September 25, 2023

SUBJECT: Review of Groundwater Supply Information for the Moriarty Holdings Cannabis Cultivation Project, APN 101-070-069, 7015 Long Canyon Road, Santa Barbara County, California

Figure 1
 Regional Map
 Moriarty Properties Project Review

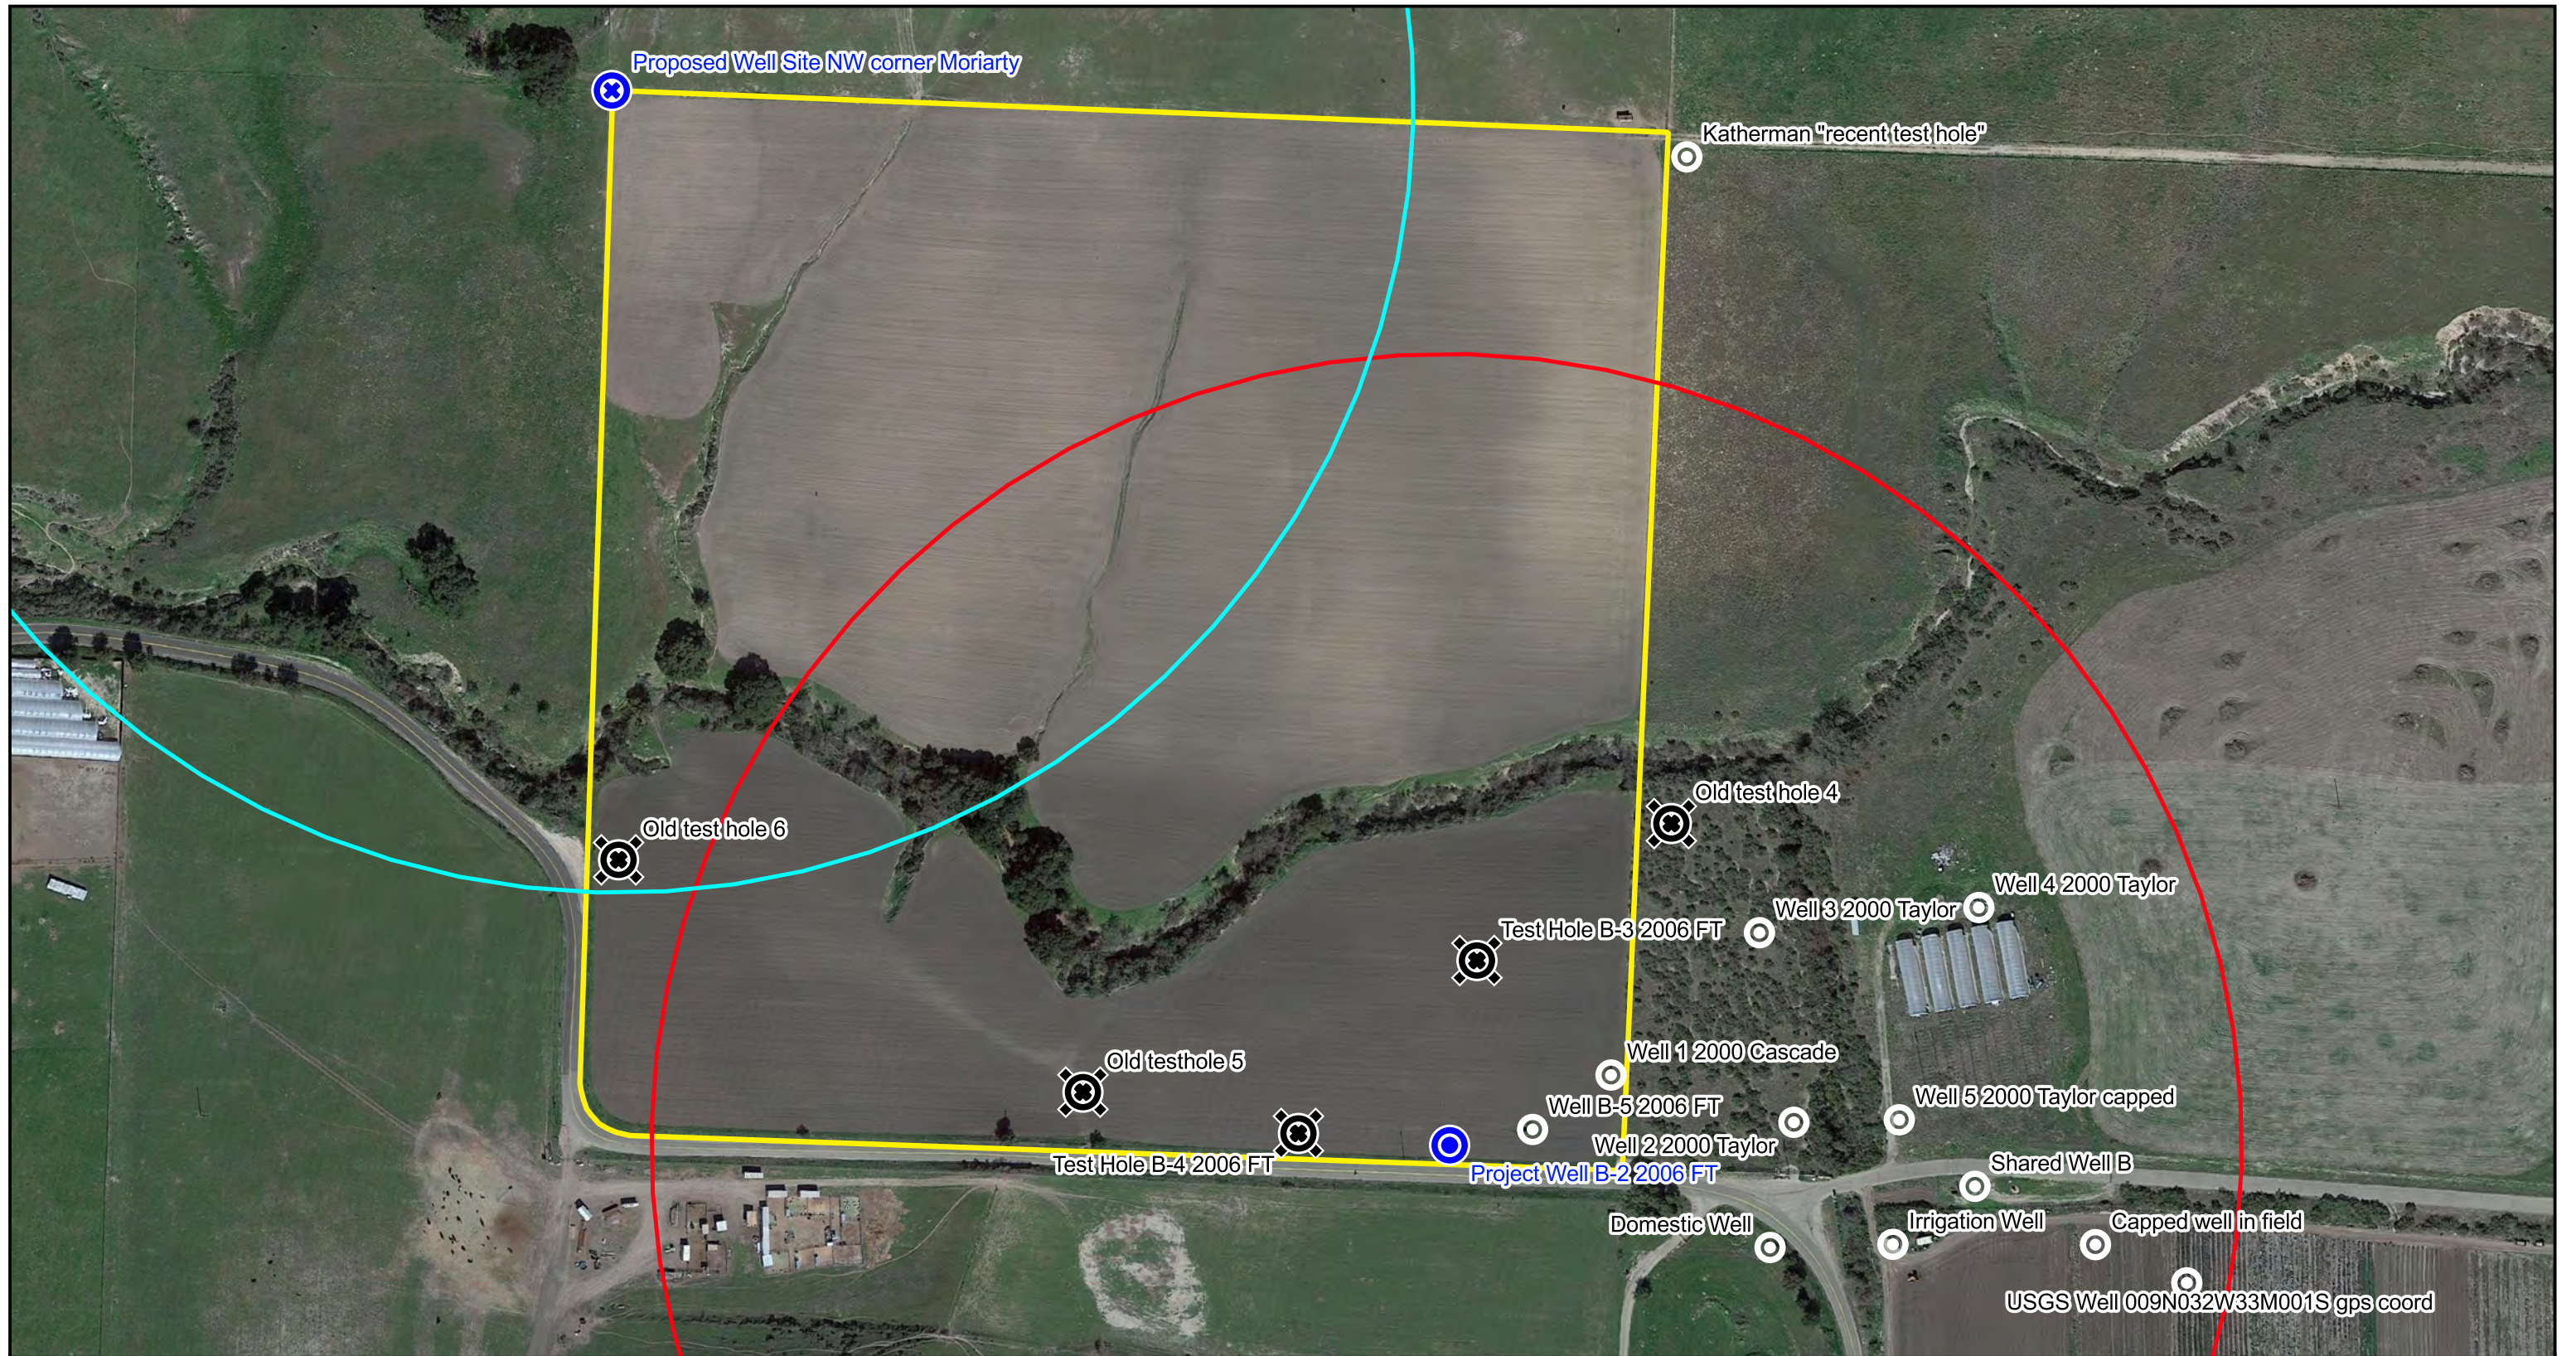
The potential for finding sufficient water from a well at the northwestern corner of the property (Figure 1) was considered likely by Kear Groundwater in their 2021 report based on their characterization of the Careaga Formation. They did not differentiate between the two members of the Careaga Formation which have very different hydrogeologic properties. The upper member of the Careaga Formation, the Graciosa member, is very permeable while the lower member of the Careaga Formation has a much lower permeability. The proposed 650-foot deep well is likely to drill into Cebada member of the Careaga, not the Graciosa member and at depth into the Sisquoc Formation that is comprised of low permeability clayey silt beds.

Figure 3
Groundwater Level Hydrograph
USGS 344836129153001
9N/32W-33M002S

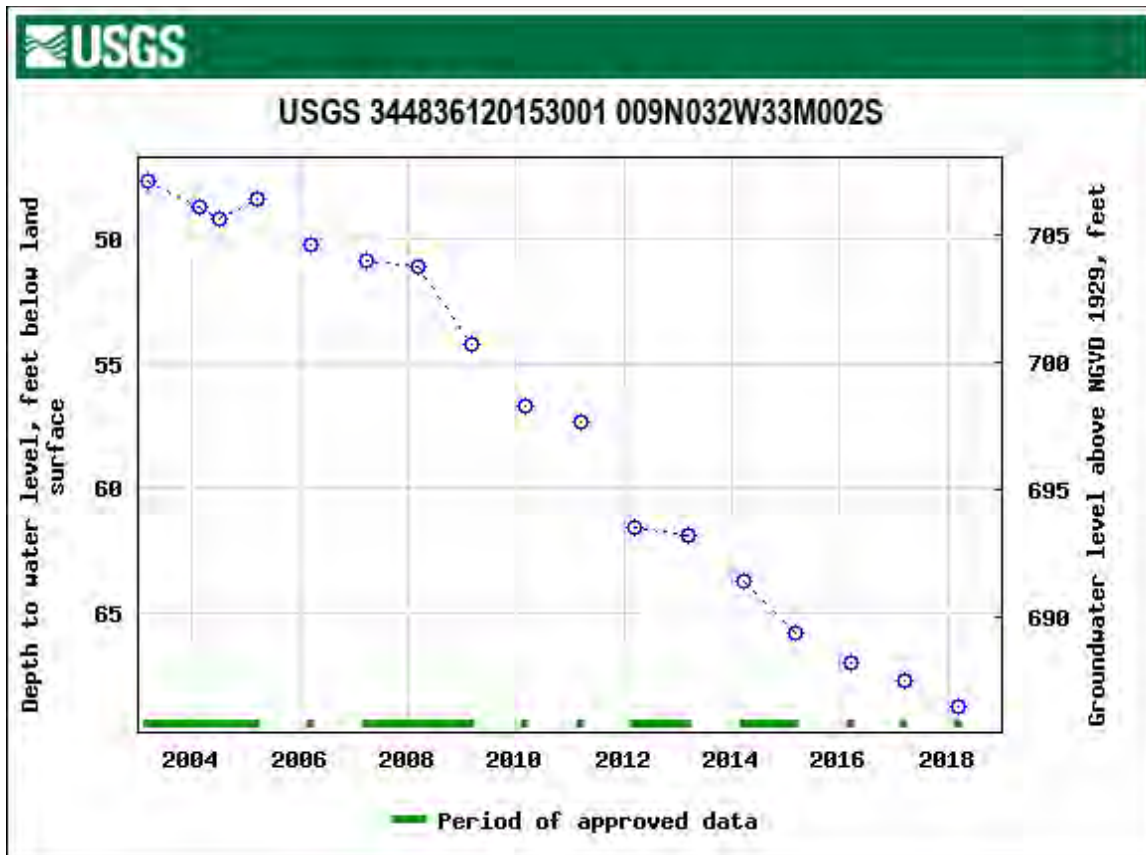
The groundwater level in the alluvial aquifer declined steadily at a rate of 2.8 feet per year from 2002 to 2022, from about 46 feet to 74 feet depth (see Figure 3). At this water level decline rate (without the increased pumpage resulting from the project), the 96-foot deep shared well about 800 feet to the east of the project well would go dry in about 20 years. As a result of the declining water level, pumping rates in wells producing from the alluvial aquifer have declined. In this shared well, the pumping rate has declined from 14 gpm (on 6/13/2017, with a depth to static level of 70 feet and a depth to pumping level at 4 hours of 82 feet) to 10.2 gpm (on 6/2/2022, with a depth to static level of 74 feet and a depth to pumping level at 4 hours of 87 feet). The project well will experience the same decline in water level and production as this shared well. Therefore, the project’s alluvial well should not be considered a reliable source of water for the project and it’s use would result in an increase in the dewatering of the aquifer and impact the production of groundwater from existing wells.
